OHIO TURNPIKE AND INFRASTRUCTURE COMMISSION

ADDENDUM NO. 3

**PROJECT NO. 43-17-04
BRIDGE DECK REPAIR AND BRIDGE REMOVAL
OHIO TURNPIKE OVER QUARRY ROAD, M.P. 138.0
OHIO TURNPIKE OVER INACTIVE RAILROAD, M.P. 138.2
LORAIN COUNTY, OHIO**

Project 43-17-04 – Plan Sheets 3 through 9, 14, and 17 through 21 of 50;
Bid Schedule of Items for Ref. 3, 5, 8, 9, 9A, 9B, 15, 16, 26, 26A, 26B, 29A, 29B, 31A, 41, 49A

REVISIONS
ADDENDUM #3
.
.

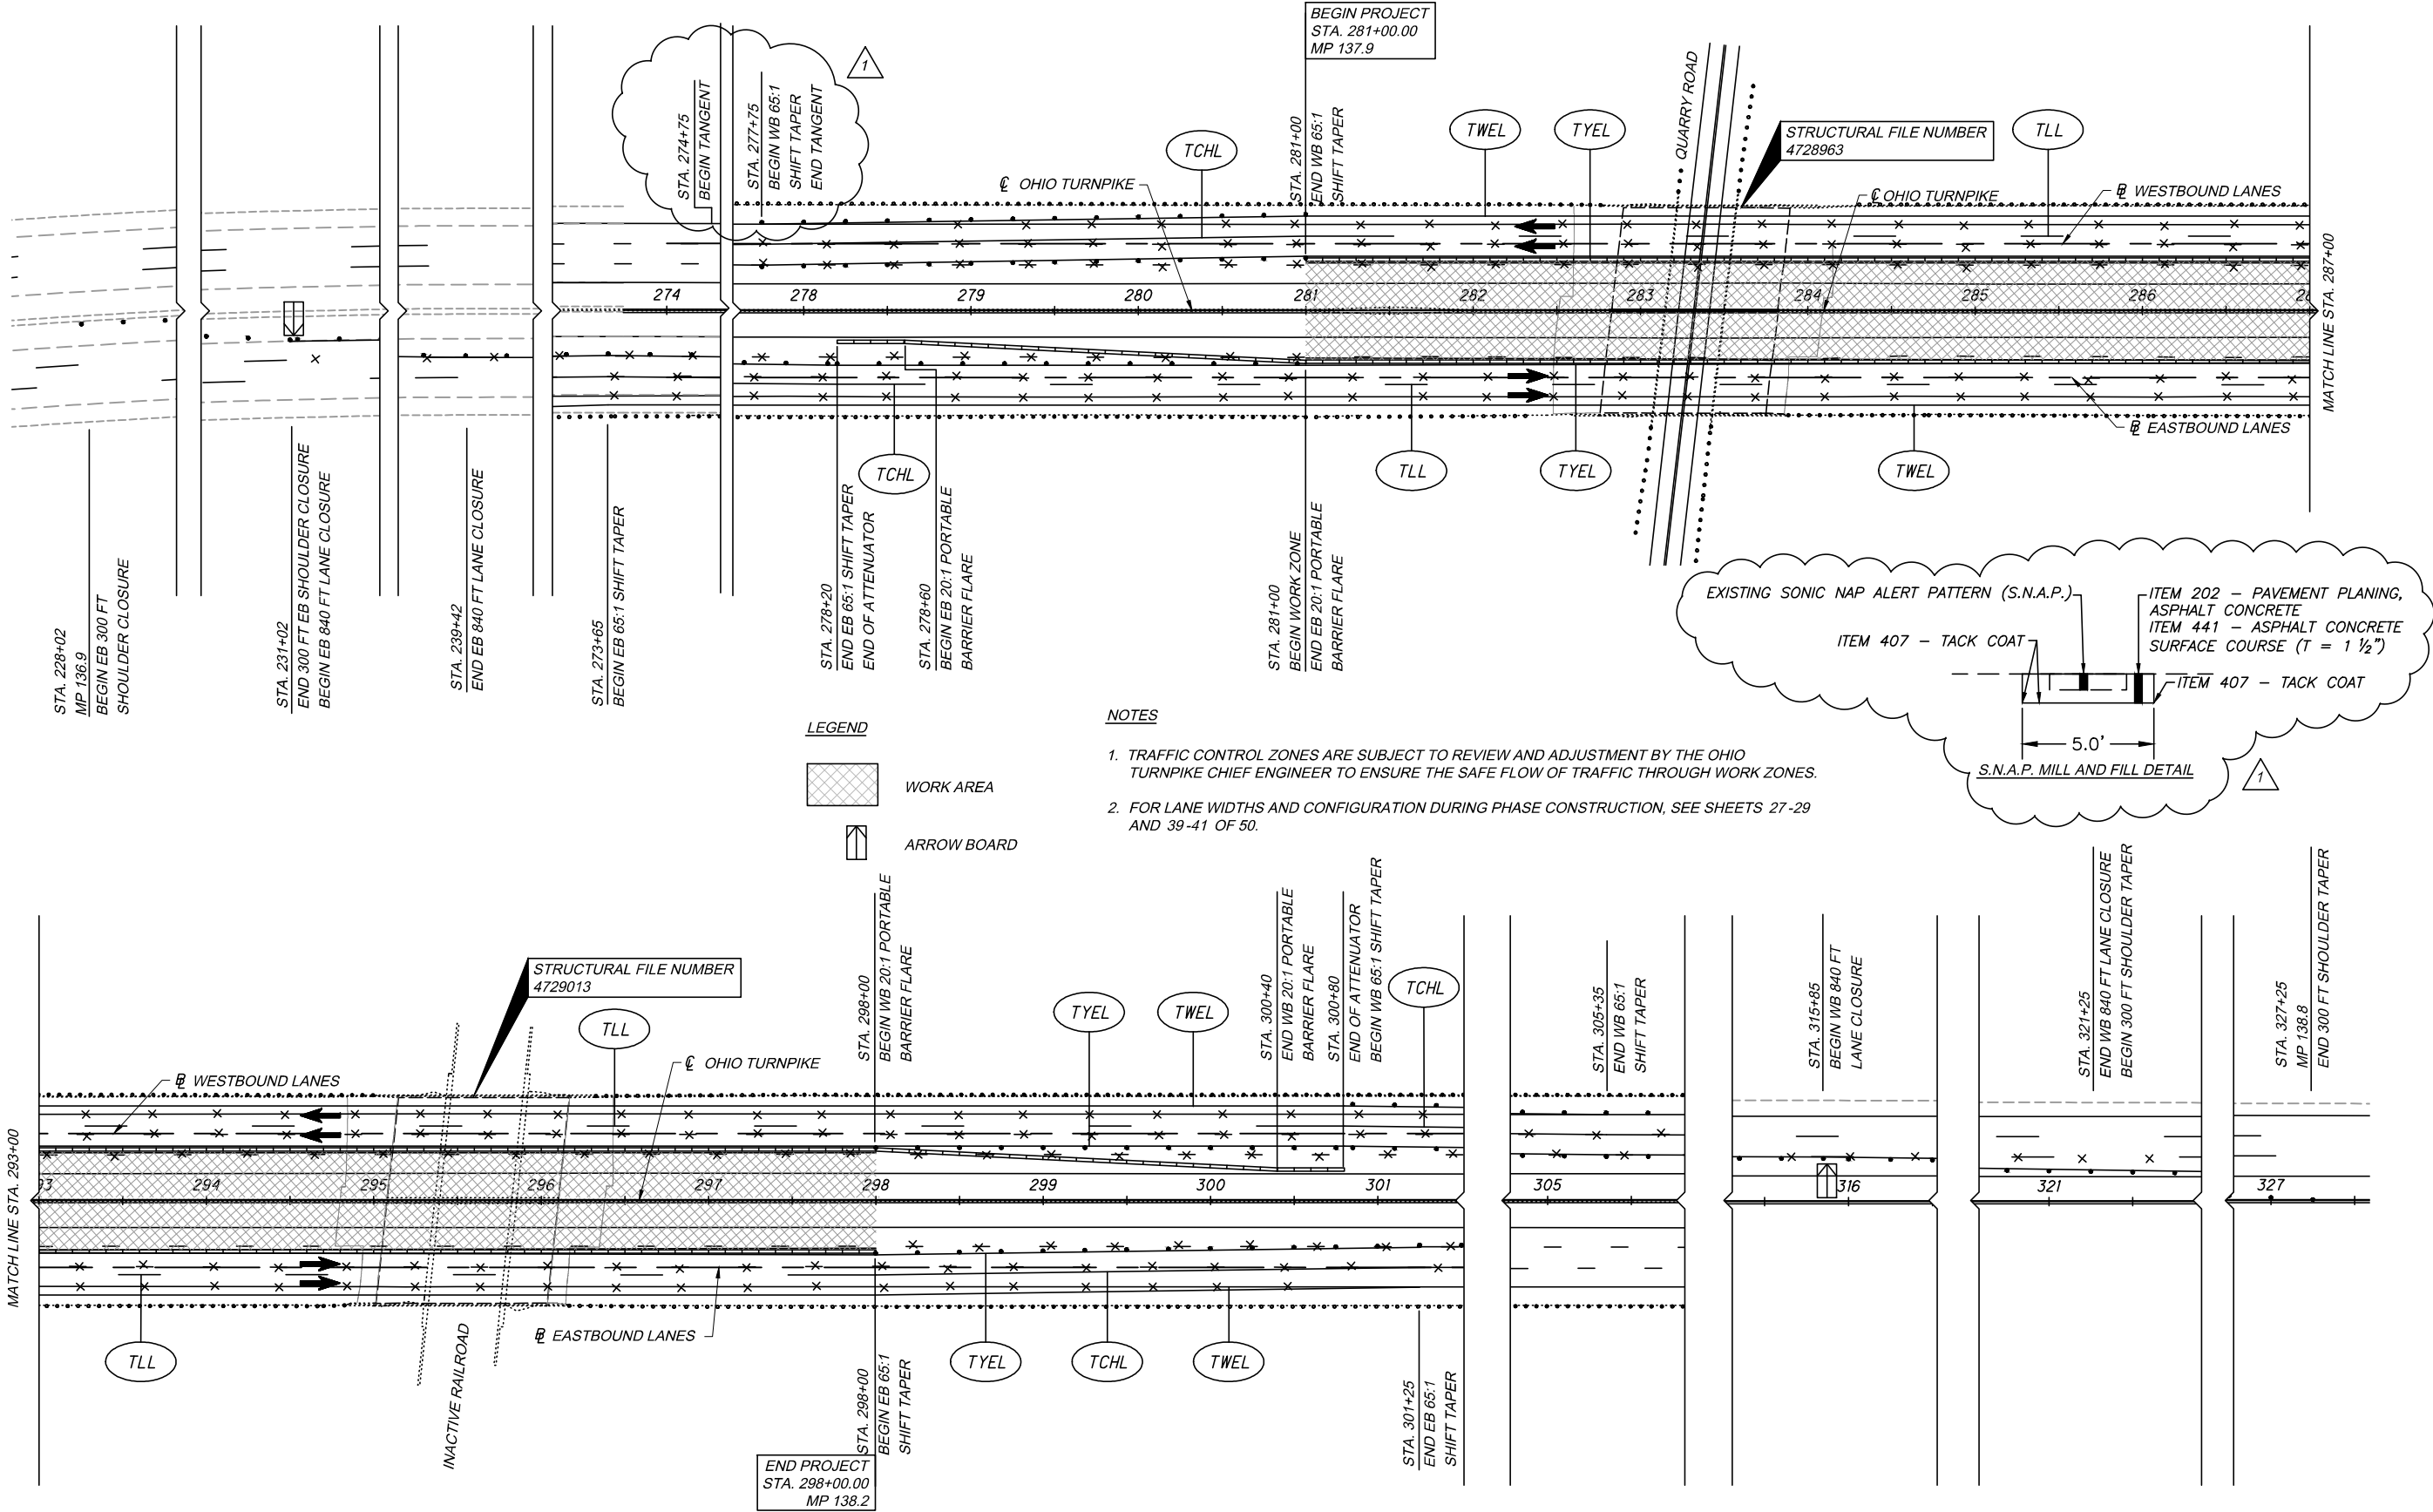
Q#9 Bid Item 86, Plan sheet 8 - Item 614 PCMS APP note states in the first paragraph that the contractor shall furnish, install, maintain, and removed 2 each PCMS. However in the last paragraph of the note it states to provide 4 PCMS, each sign for approximately 2920 Days. Is the contractor supposed to provide 2 each or 4 each of these?

A#9 This Addendum No. 3 revises the Item 614 - Portable Changeable Message Sign, As Per Plan note on Plan Sheet 8 of 50 to read "...PROVIDE TWO (2) PORTABLE CHANGEABLE MESSAGE SIGNS, EACH SIGN FOR APPROXIMATELY 730 DAYS, FOR AN ESTIMATED TOTAL OF 1460 DAYS" and also revises the quantity in the same note from 2920 days to 1460 days. In addition, the quantity for Reference No. 86, Item 614, Portable Changeable Message Signs, As Per Plan, has been revised from 2920 days to 1460 days on Plan Sheet 6 of 50 and Reference No. 86.

THE FOLLOWING ESTIMATED QUANTITY HAS BEEN INCLUDED IN THE GENERAL SUMMARY FOR USE AS DIRECTED BY THE CHIEF ENGINEER TO PROVIDE TWO (2) PORTABLE CHANGEABLE MESSAGE SIGNS, EACH SIGN FOR APPROXIMATELY 730 DAYS, FOR AN ESTIMATED TOTAL OF 1460 DAYS.

ITEM 614, PORTABLE CHANGEABLE MESSAGE SIGN, AS PER PLAN 1460 DAY

PLAN AND PROFILE
STA. 292+00 TO STA. 297+00
MP 138.0 AND MP 138.2

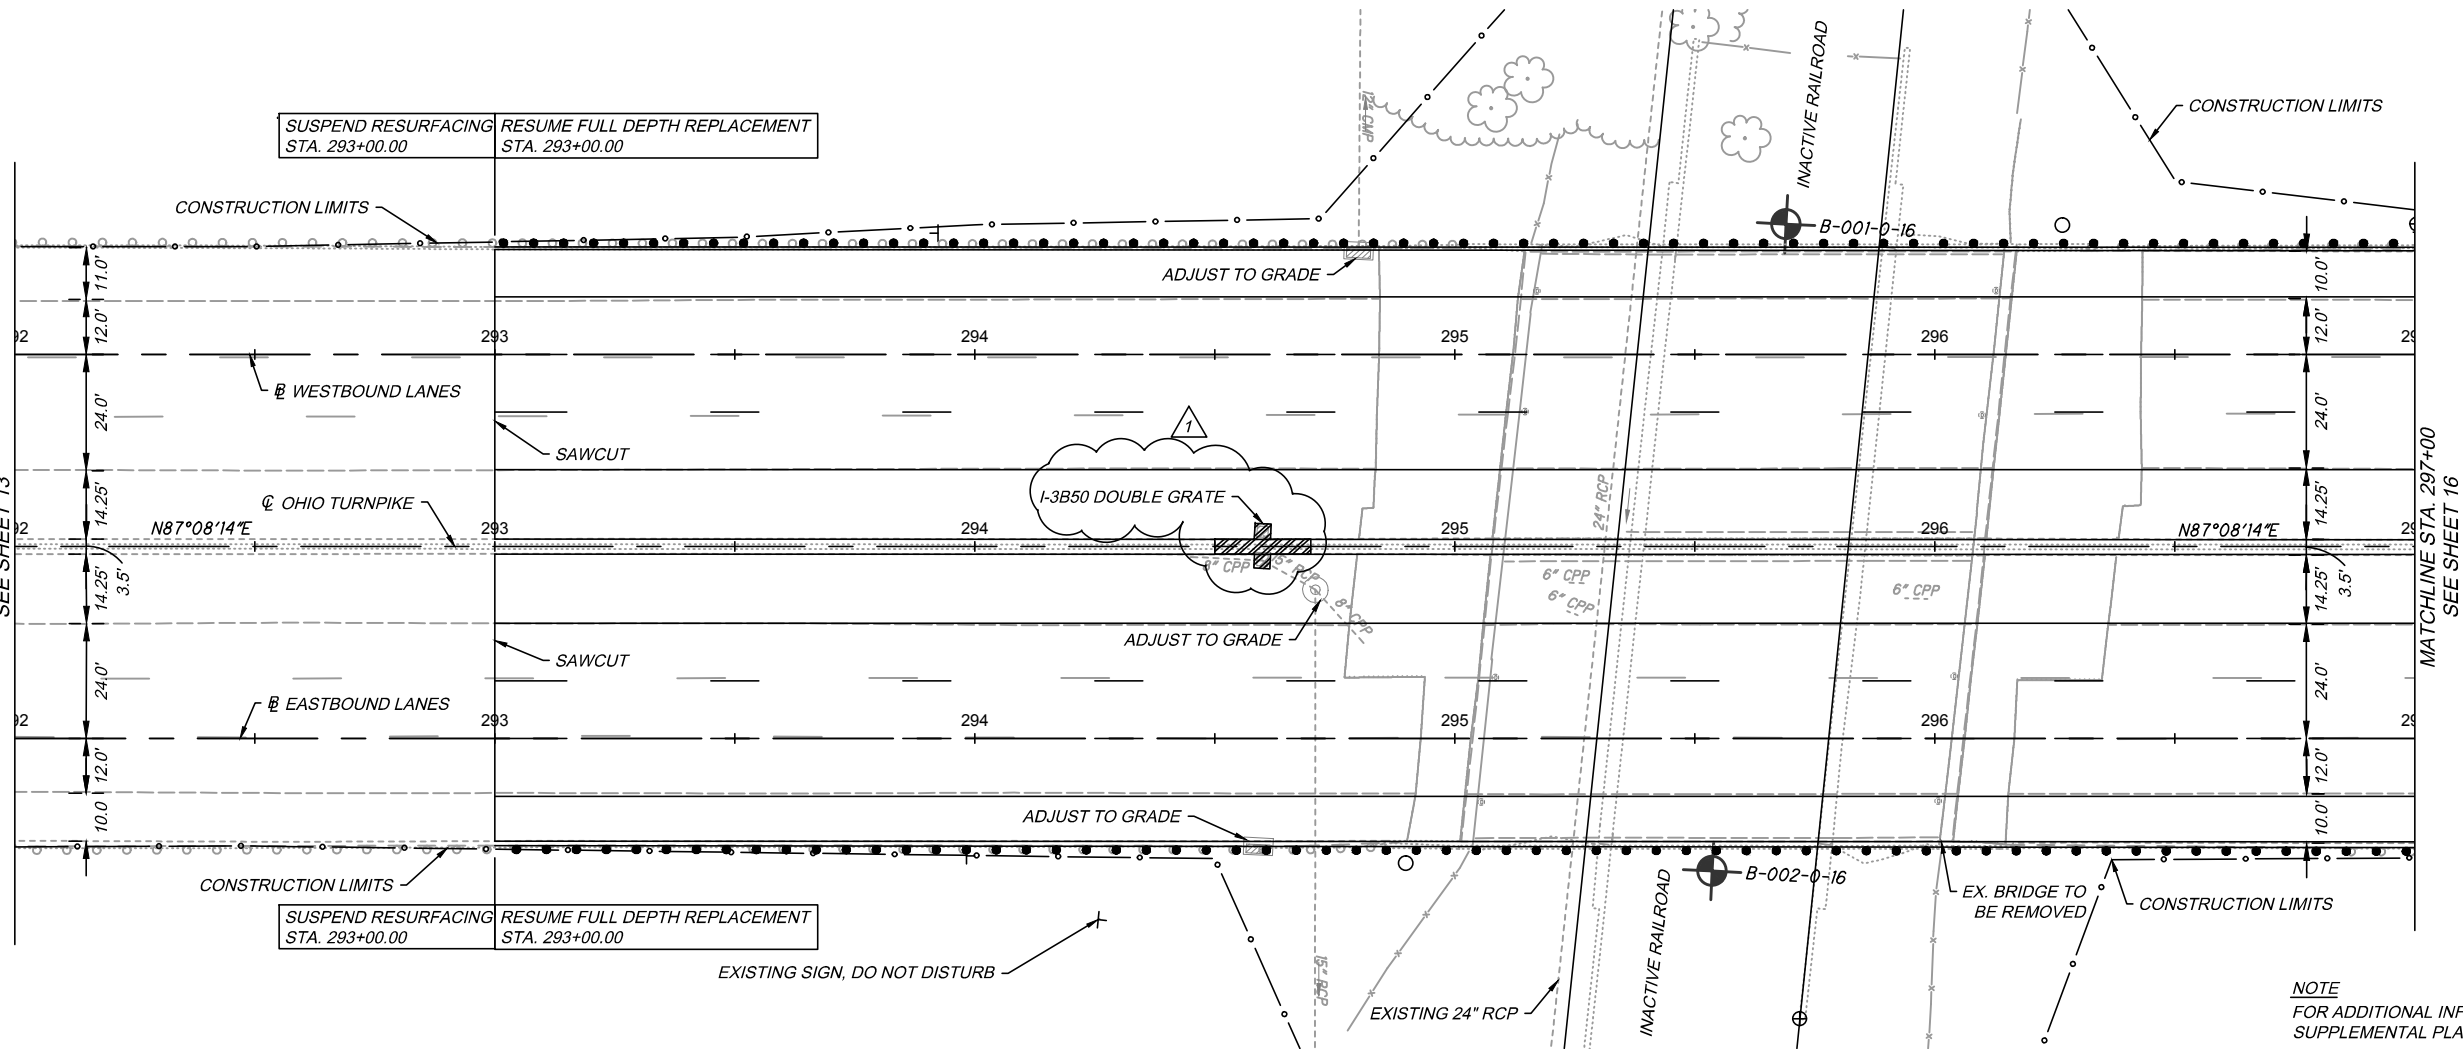
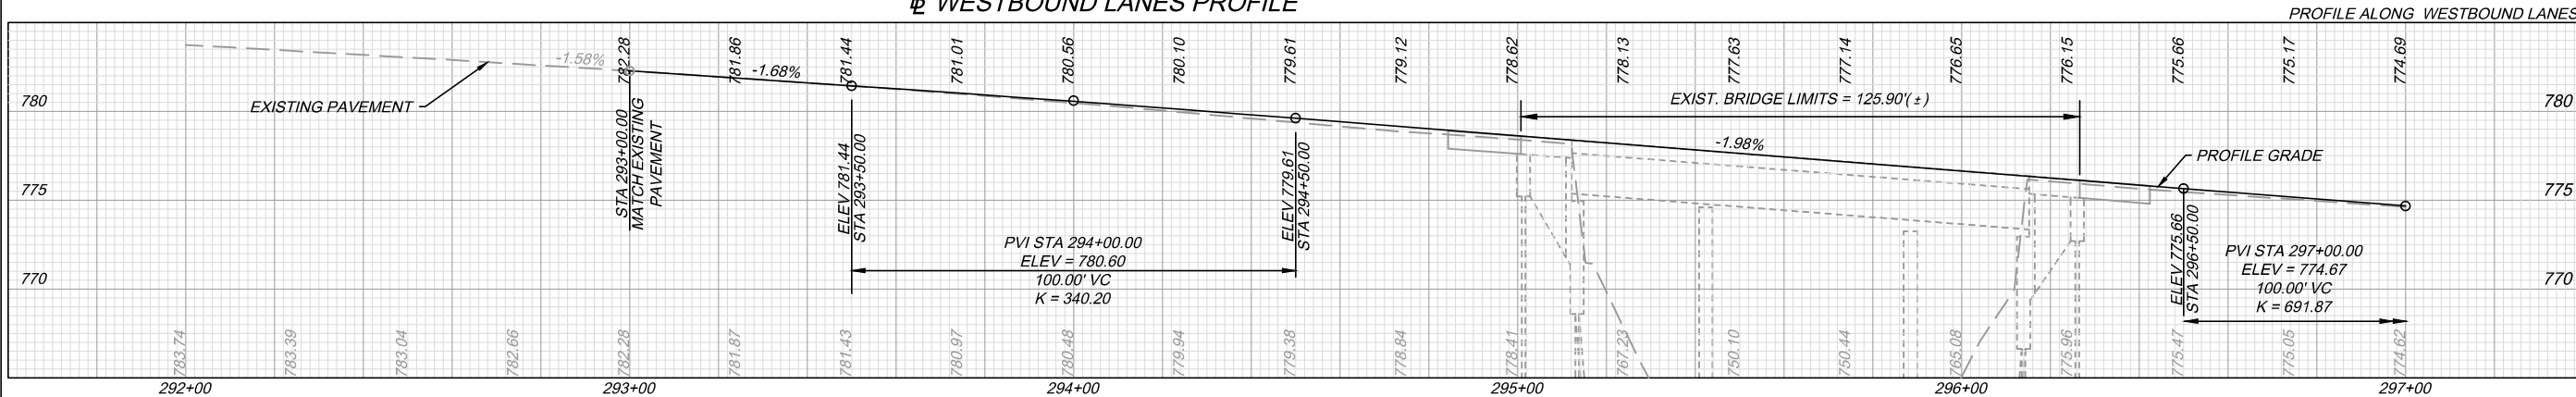
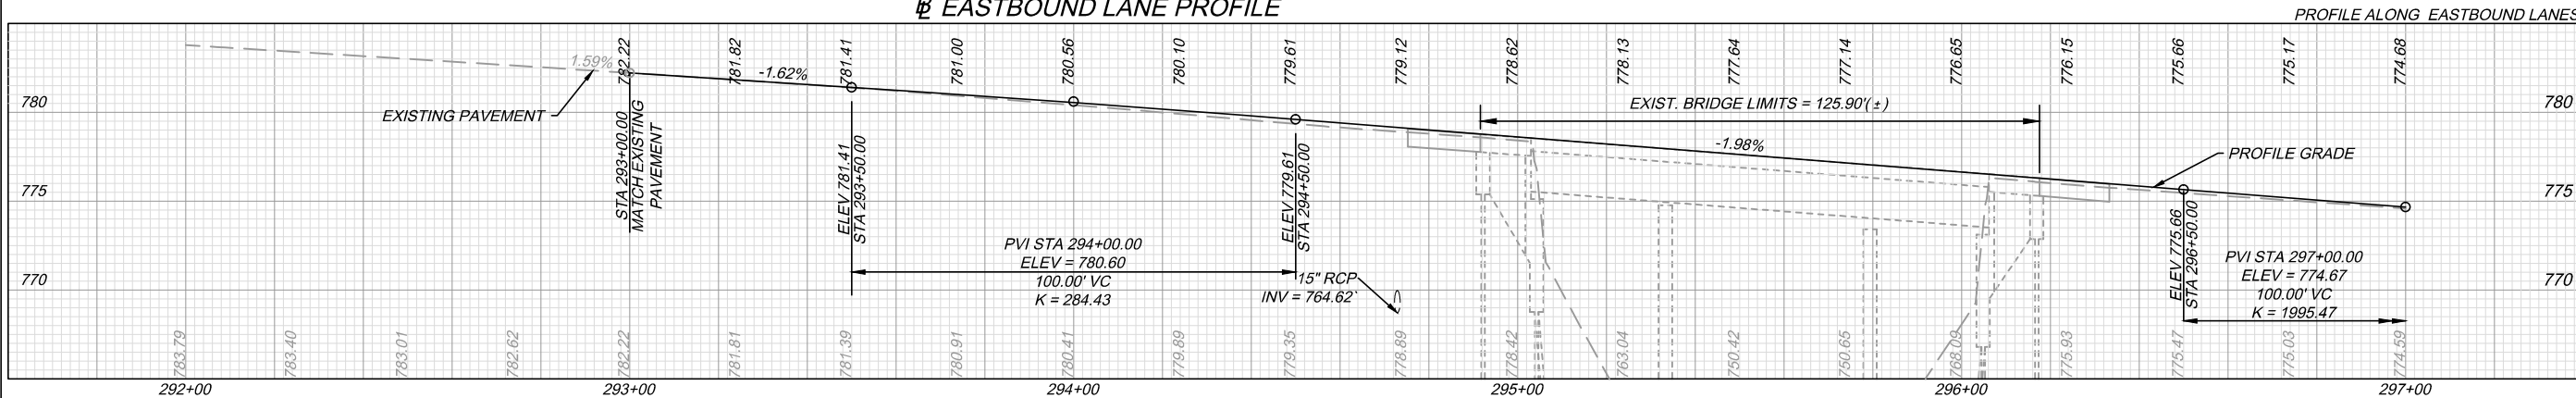
With this Addendum No. 3, the Commission substitutes the enclosed materials for the following Contract Documents:

Plan Sheets 3 through 9, 14, 17 through 21 of 50; and
